CLINIC SERVICE SINK

Shop Drawing Submittal Review

Project Name: Webster University-**ISB**

SPEC SECTION: 22 4216.16
Commercial Sinks

CSS-1 CLINICAL SERVICE SINK PER ADDENDUM #2-1

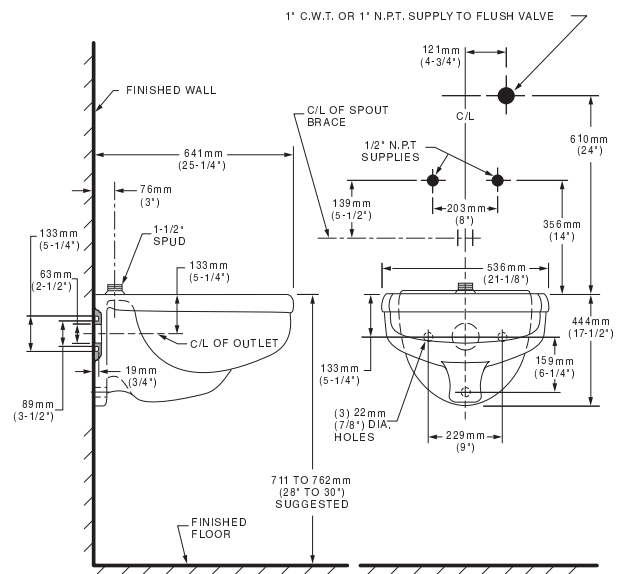
NEC	MCN	AAR	REJ	REV	NO EXCEPTION TAKEN	
					MAKE CORRECTIONS NOTED, NO RESUBMITTAL:	
					AMEND AND RESUBMIT	
					REJECTED, SEE REMARKS:	
					REVIEWED ONLY	
					ITEM	REMARKS
Clinical Service Sink CSS-1						
X					Fixture American Standard Model 9512.999.020	
X					Rim Guard American Standard Model 7832512.075	
X					Faucet American Standard Model 8345.115	
X					Flush Valve Sloan Model Royal 117	
X					Fixture Carrier Wade Model 640	
Scrub Sink SS-1						
X					Fixture Elkay Model EEWSF 13026SACC	Manufacturers Complete Surgical Sink Package with Sensor Faucet and Grid Drain and Thermostatic Mixing Valve
